DEPARTMENT OF THE ARMY  
CORPS OF ENGINEERS, PORTLAND DISTRICT  
PO BOX 2946  
PORTLAND OR 97208-2946

On June 9, 2016, the Environmental Protection Agency (EPA) issued the Proposed Plan (Plan) for the remediation of the Portland Harbor Superfund Site for public comment through September 6, 2016. The U.S. Army Corps of Engineers Portland District (Corps) has reviewed the document and is providing comments on the Plan and supporting Feasibility Study with this letter.

**Table 1.** Corps of Engineers, Portland District comments on the proposed Plan/Feasibility study for cleaning up the Portland Harbor Superfund Site.

Figure 1.2-9a. Distribution of Surface Sediment Chemistry for Total PAHs

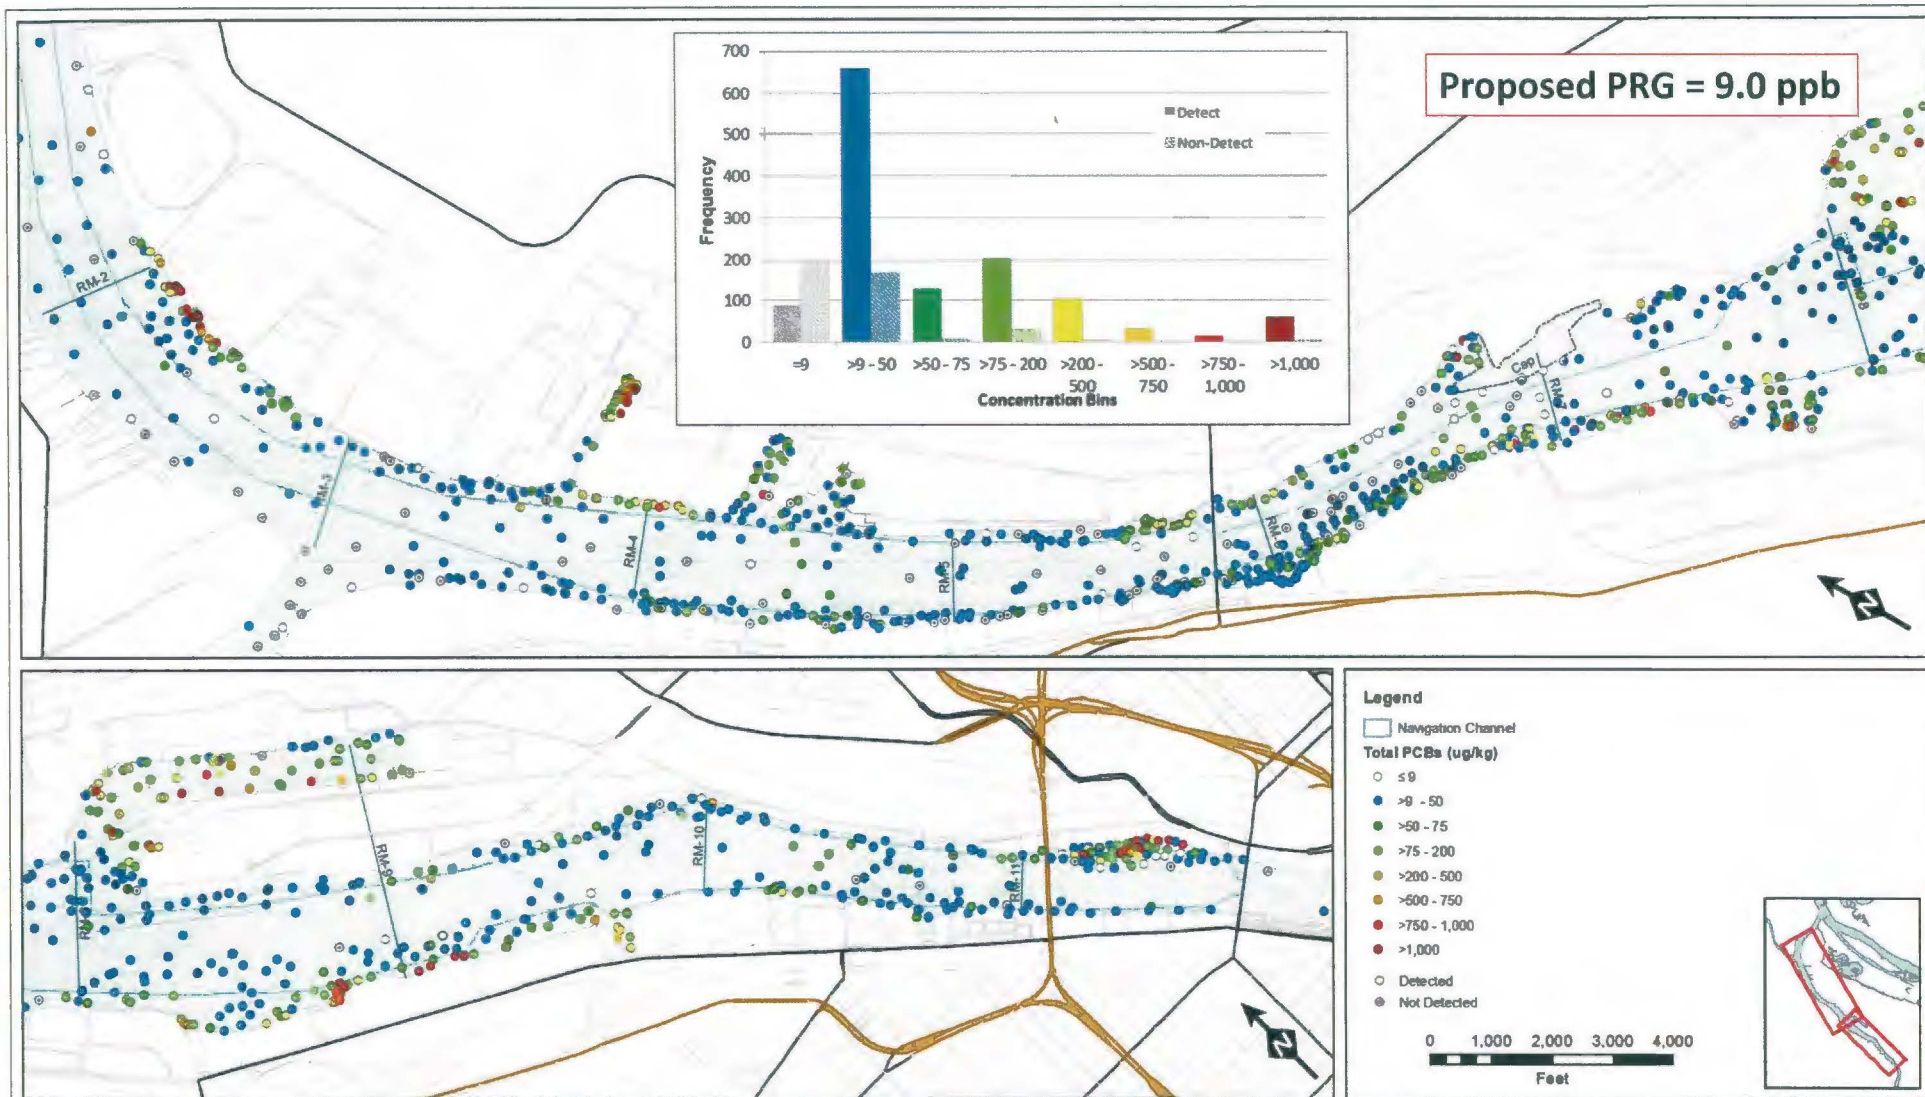
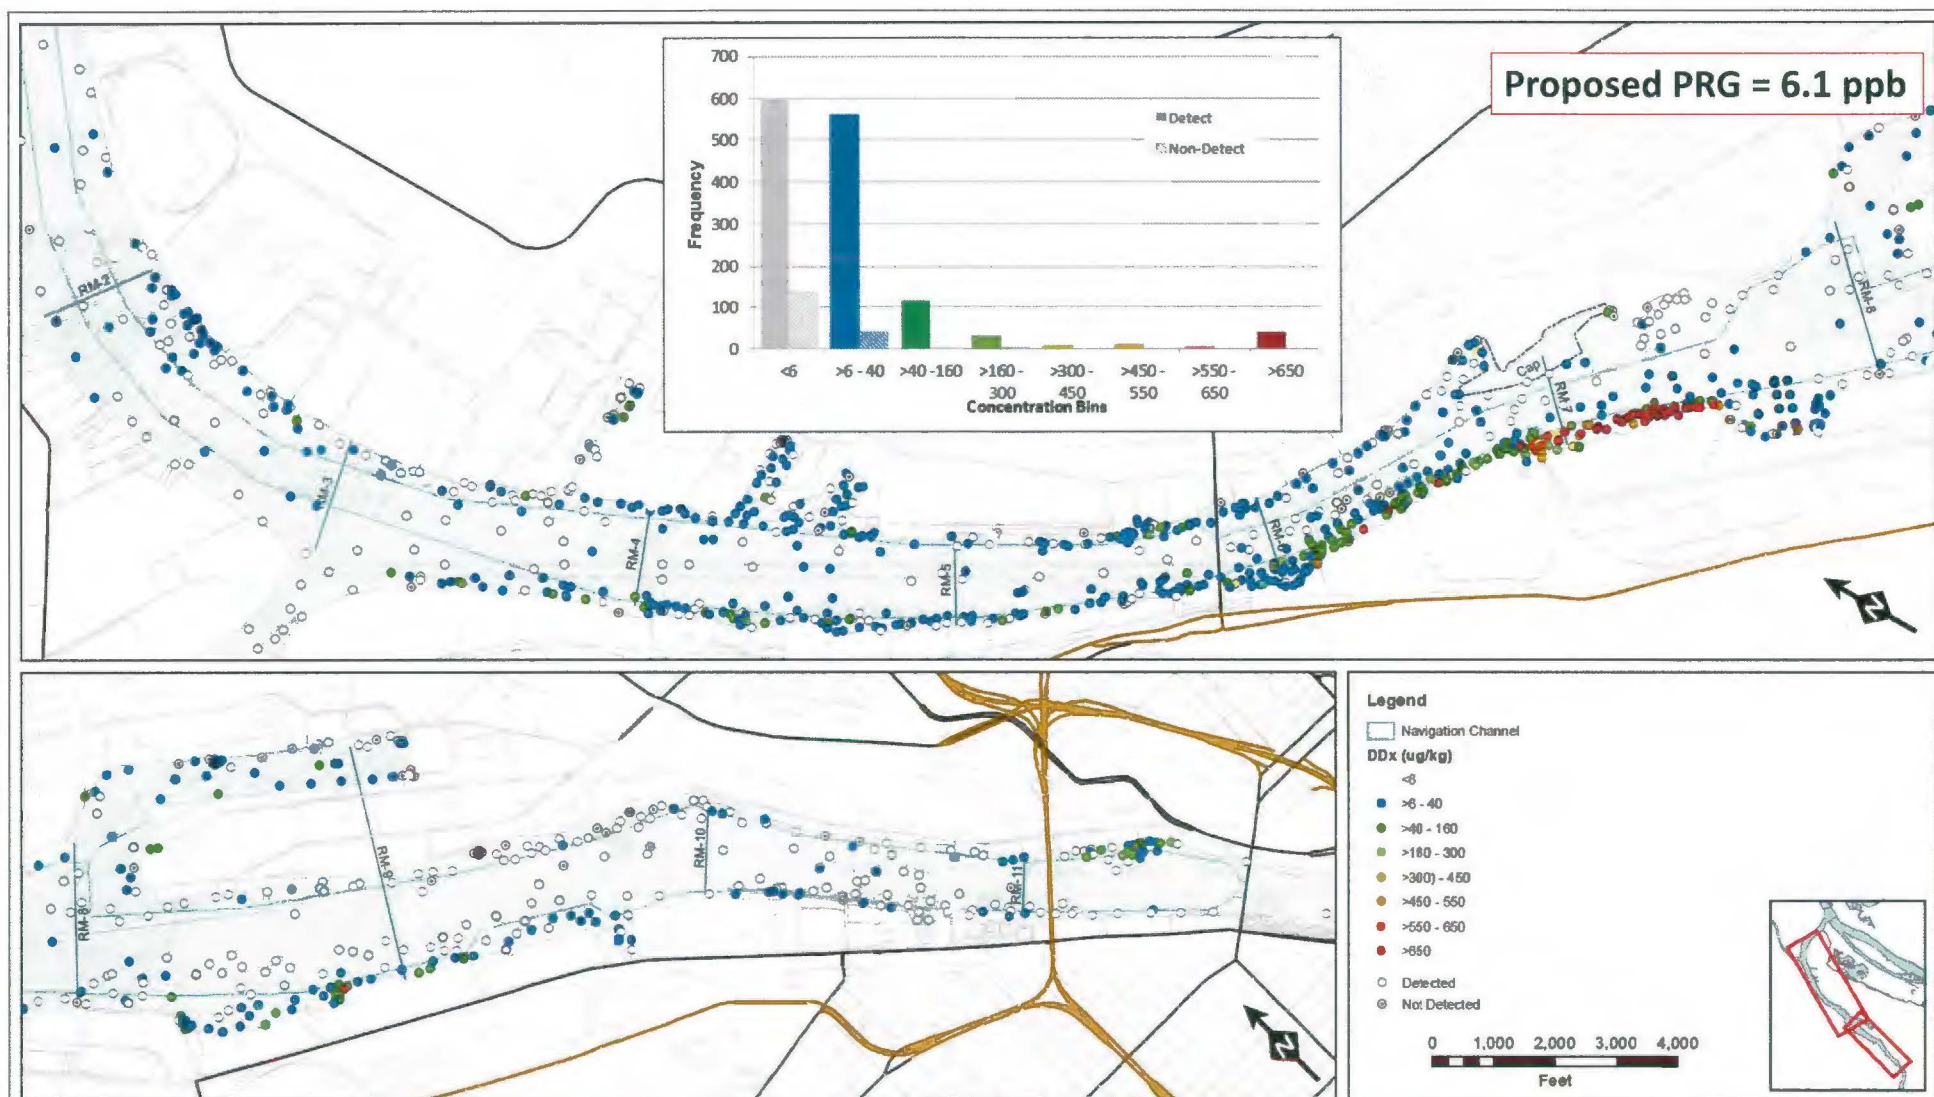
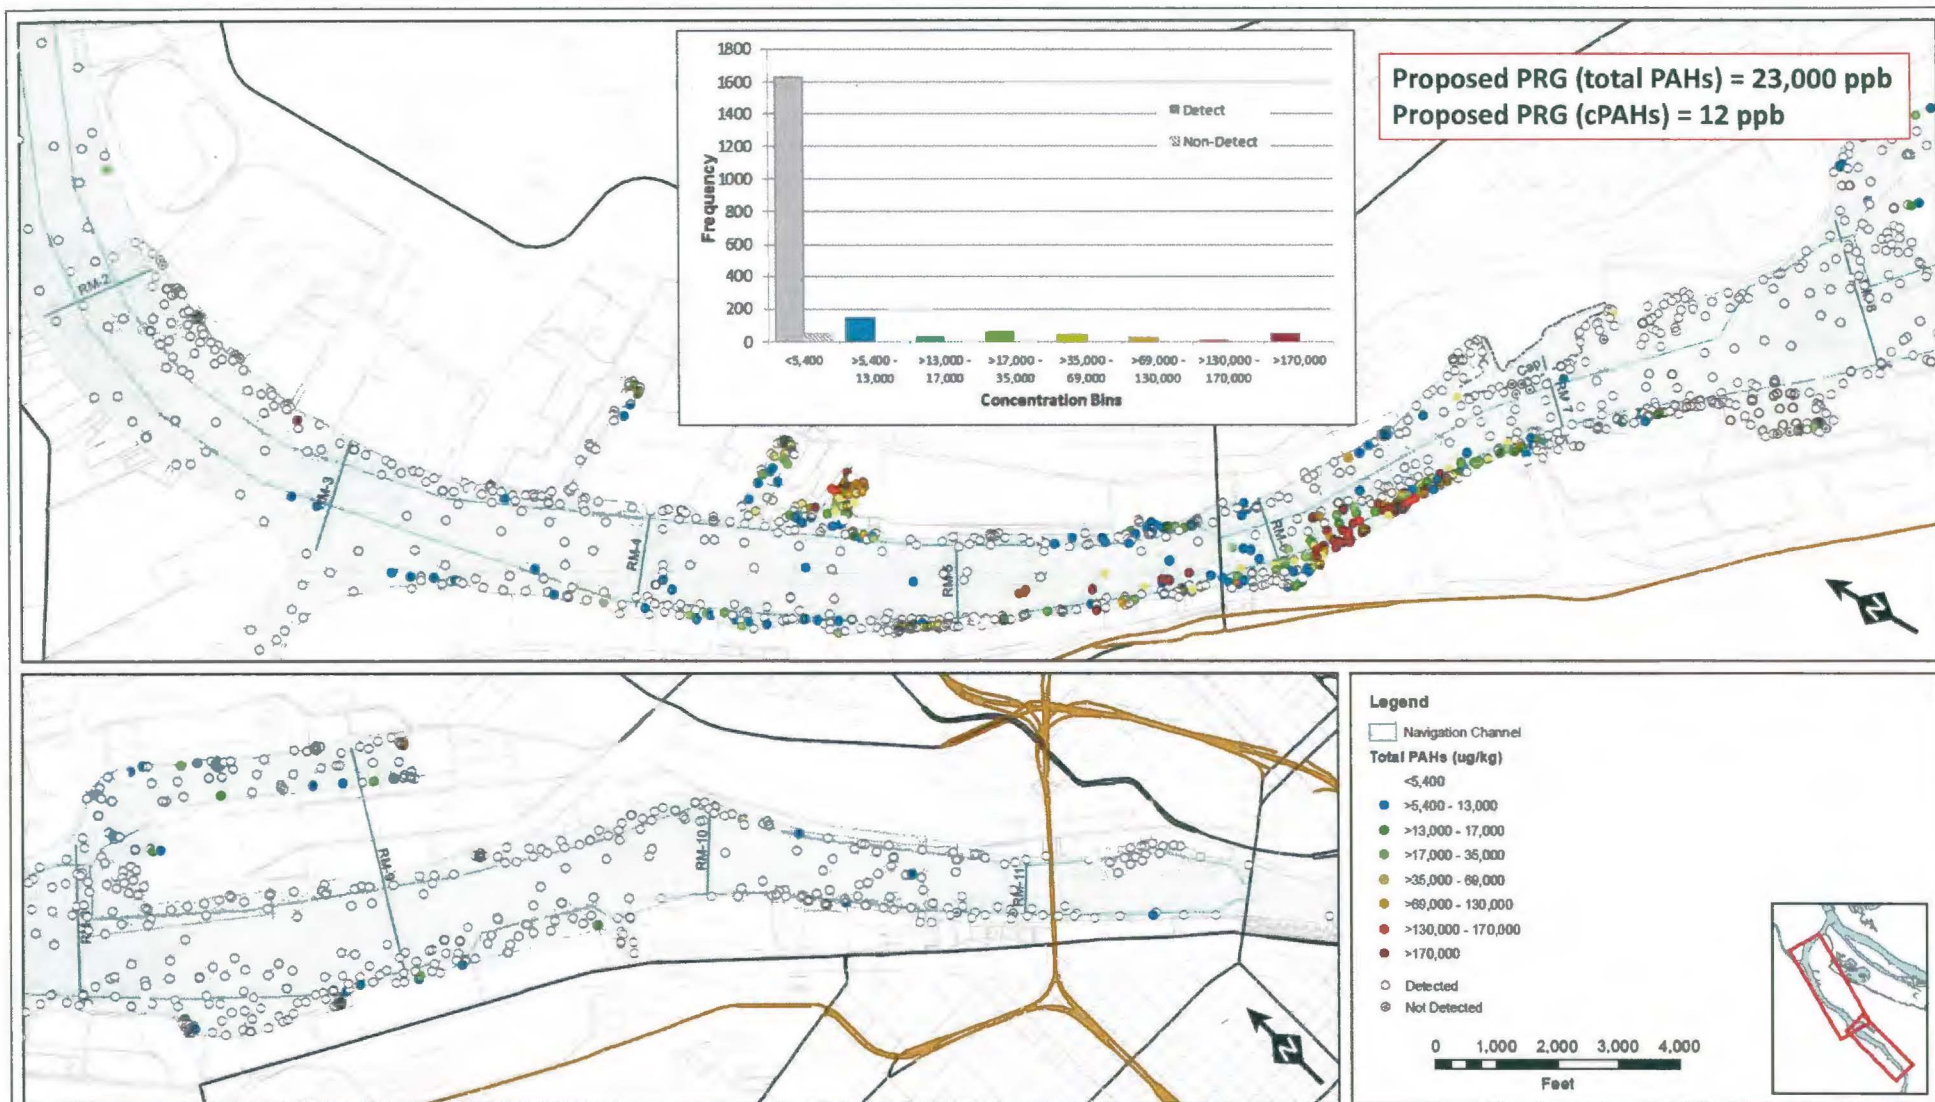
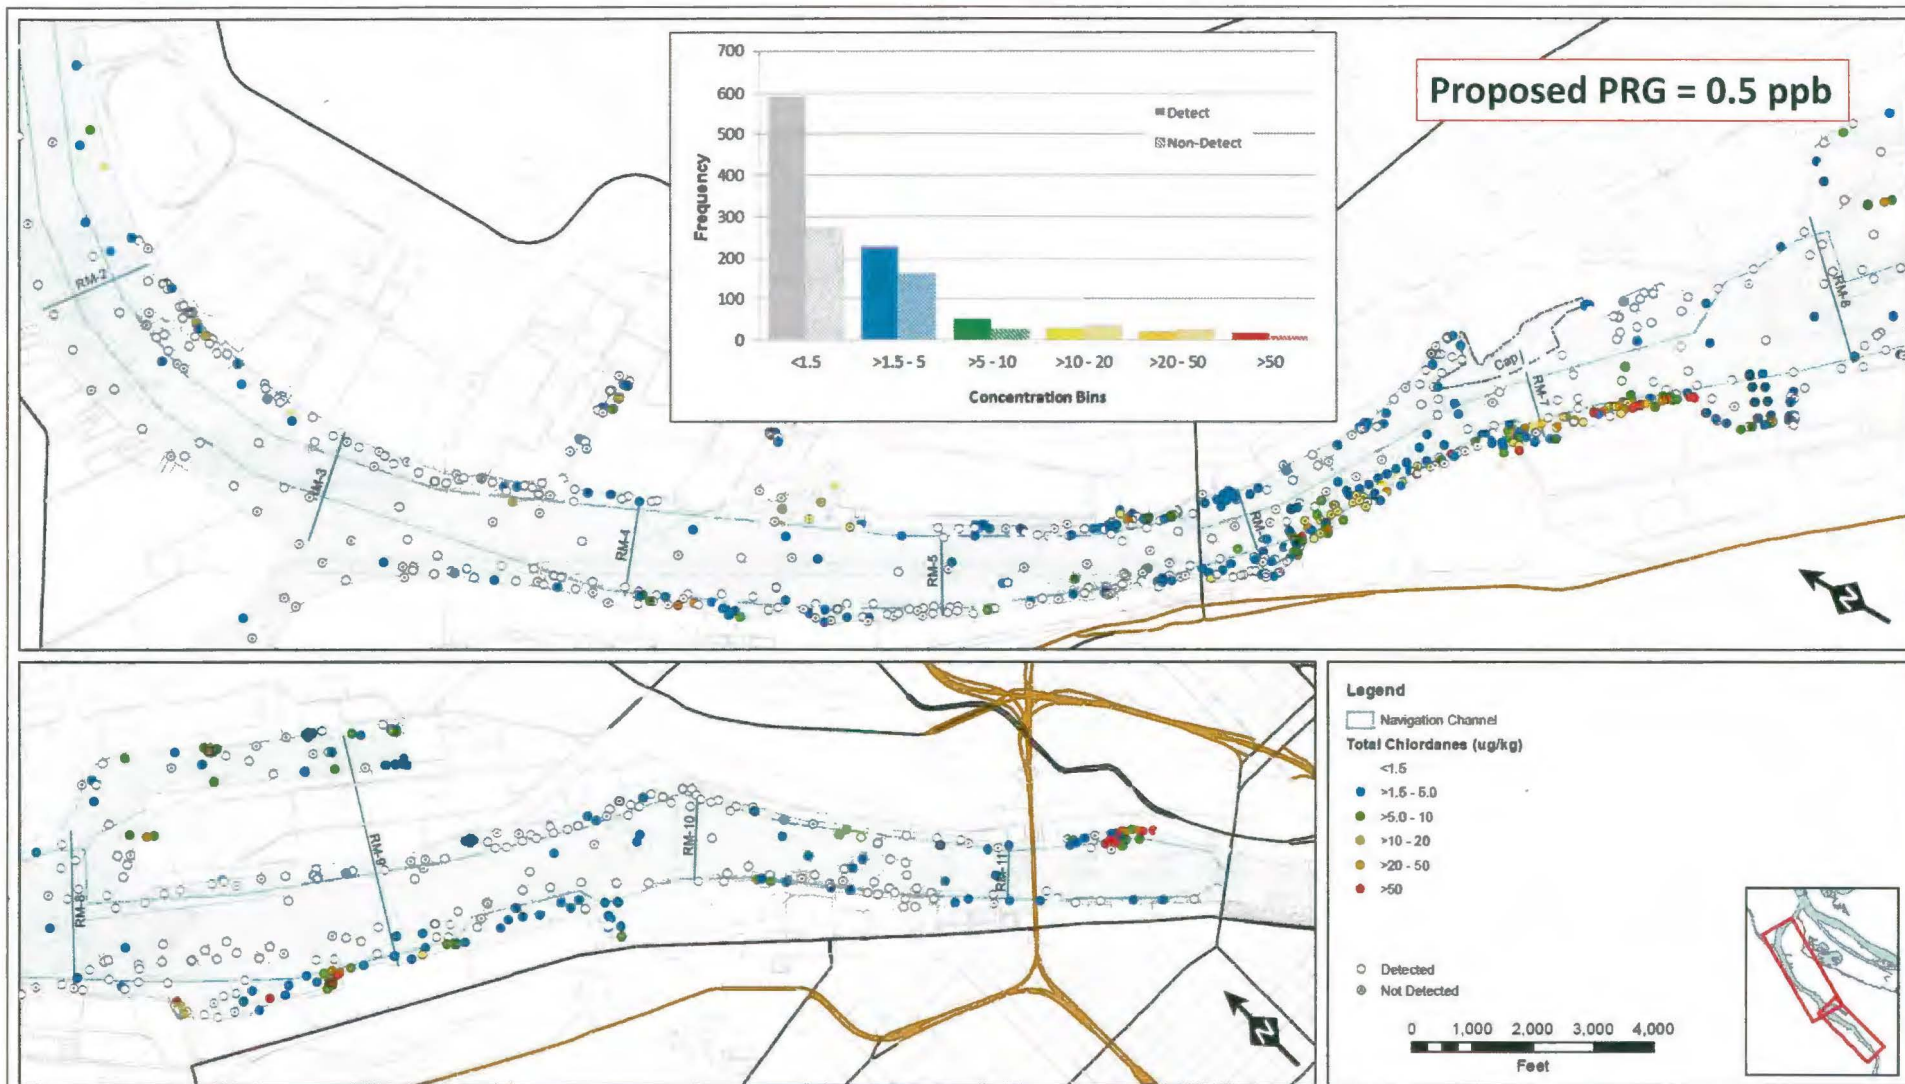
Sediment Quality	Feasibility Study	Figures 1.2-6a/b to 1.2-18a/b	<p>Figures 1.2-6a/b to 1.2-18a/b of the Feasibility Study provide clear, visual evidence that EPA's proposed PRGs are unattainable. Most of these figures show chemical concentrations above the proposed PRGs distributed throughout the non-cleanup portions of the Harbor (Attachment B). With low-level concentrations of contaminants so broadly distributed throughout the Harbor, and outside of proposed sediment management areas, please explain how the proposed PRGs will be achieved in a reasonable timeframe.</p>

Discipline/ Area of Interest	Document	Document Location	Comment
			<p>E.g., EPA's proposed PRG for total PCBs is 9.0 ppb. Out of approximately 1,200 detected results, approximately 600 surface sediment samples have total PCBs concentrations ranging from &gt;9 to 50 ppb; many of which are outside of proposed sediment management areas. Another 400 samples show total PCBs concentrations ranging from &gt;50 to &gt;1,000 ppb. Only 200 samples had total PCBs concentrations at 9 ppb or less. Therefore, how does EPA expect to achieve a remedial goal of 9 ppb or less, when 83% of the surface sediment distributed throughout the Harbor contains concentrations greater than 9 ppb total PCBs, and only 50% of the surface sediment <u>in non-cleanup areas</u> ranges from 9 to &lt;50 ppb?</p> <p>EPA's proposed PRG for arsenic is 3 ppm. Approximately 1,200 surface sediment samples have arsenic concentrations ranging from &gt;3 to 10 ppm and less than 100 samples are above 10 ppm; many of these points are outside of proposed sediment management areas. Approximately 450 points are &lt;3 ppm. How does EPA expect to achieve a remedial goal of 3 ppm or less, when most of the sediment outside of proposed sediment management areas ranges from 3 to 10 ppm?</p>

Sediment Quality	Feasibility Study	Figures 1.2-6a/b to 1.2-18a/b	EPA has developed proposed PRGs for most of the compounds depicted in these figures. The break between the lowest concentration group and the next-lowest concentration group needs to be the same as the PRG. For example, in Figures 1.2-11a/b (total chlordanes), the lowest concentration grouping ranges from 0 ppb (non-detect) to 1.5 ppb, and the next grouping ranges from >1.5 to 5.0 ppb. However, the proposed PRG for total chlordanes is 0.5 ppb. Please modify these figures (and the inset bar graph) with the break between the lowest concentration group and the next-lowest concentration group set at 0.5 ppb.
Sediment Quality	Feasibility Study	Figures 1.2-7a/b	Since EPA has developed draft PRGs for multiple PCDD/F congeners (2,3,7,8-TCDD; 2,3,7,8-TCDF; 1,2,3,7,8-PeCDD; 2,3,4,7,8-PeCDF; and 1,2,3,4,7,8-HxCDF), please prepare separate figures showing the surface/subsurface concentrations of each congener.

Sediment Quality	Feasibility Study	Figures 1.2-9a/b	Since EPA has developed a draft PRG of 12 ppb for total cPAHs (BaP equivalent), please prepare a separate figure showing the surface/subsurface concentrations of total cPAHs with the first break at 12 ppb. This exercise will also illustrate the unattainability of this proposed PRG.
Sediment Quality	Proposed Plan/ Feasibility Study	General comment	EPA's handling of non-cleanup areas within Superfund study areas is inconsistent within Region 10. In coordination with EPA Cleanup, the interagency Washington Dredged Material Management Program (DMMP) has been allowed to evaluate routine maintenance dredging projects in the Lower Duwamish Waterway (LDW) using the guidelines published in the 2016 SEF. It is our understanding that EPA required that contaminant concentrations in the
